SERVICE BULLETIN

Service Bulletin No.: DAC1-52-03 Rev 1

Title: Canopy Lock Cover Plate Installation

Figure 1

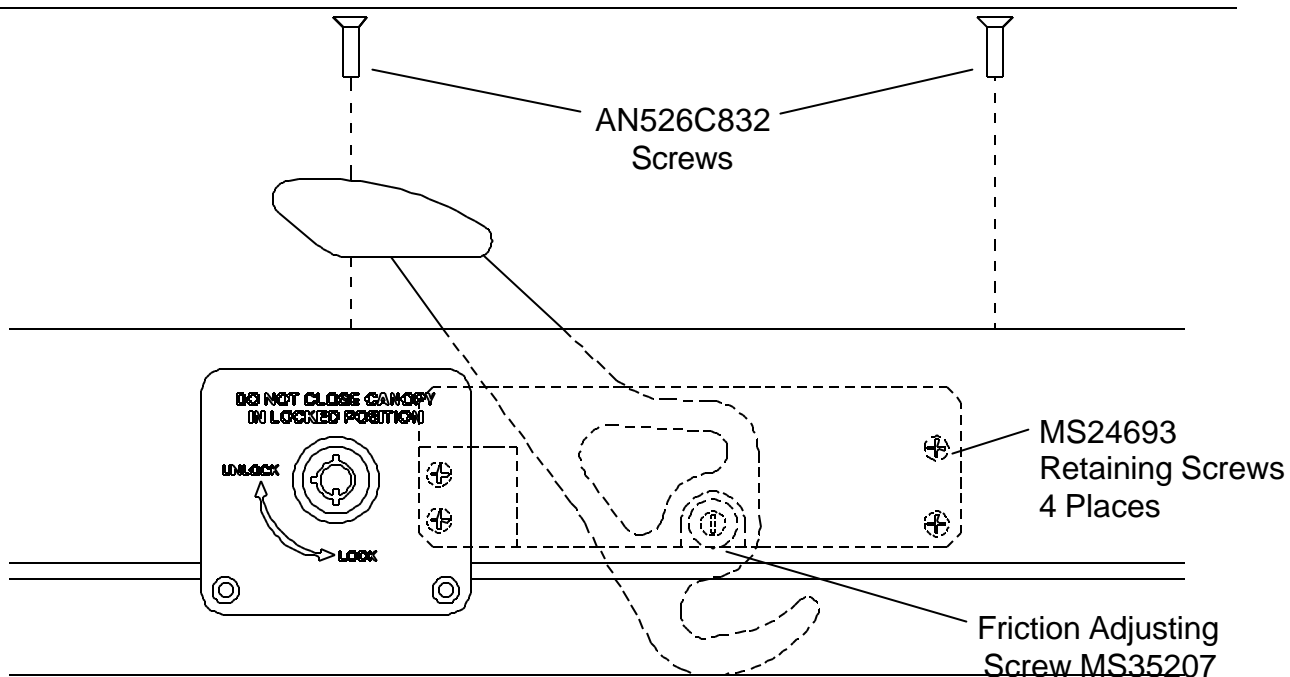
- 10.2 Remove left hand canopy latch: (Figure 1)
 - 10.2.1 Remove two AN526C832 screws retaining latch cover.
 - 10.2.2 Remove MS35207 friction adjust screw.

- 10.2.3 Remove four MS24693 retaining screws.
 - 10.2.4 Lift latch and cover upwards out of frame.
- 10.3 Remove canopy lock:
 - 10.3.1 Remove plastic plug.

Figure 2

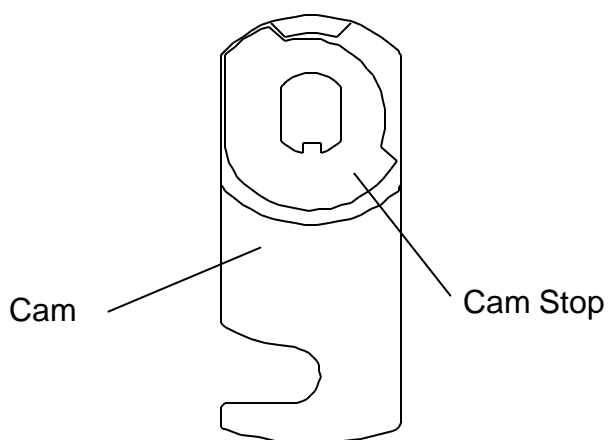
- 10.3.2 Remove cam retaining nut, lock washer, cam, and cam stop. Note orientation of cam and cam stop on shaft before removing (Figure 2).
 - 10.3.3 Remove ring nut.

- 10.19** Install canopy lock (reverse of removal). Ensure cam and cam stop are installed in correct orientation (Figure 2). Apply Loctite 222 on nut that holds cam. Install canopy latch (reverse of removal). Apply Loctite 222 to latch retaining and cover plate screws.
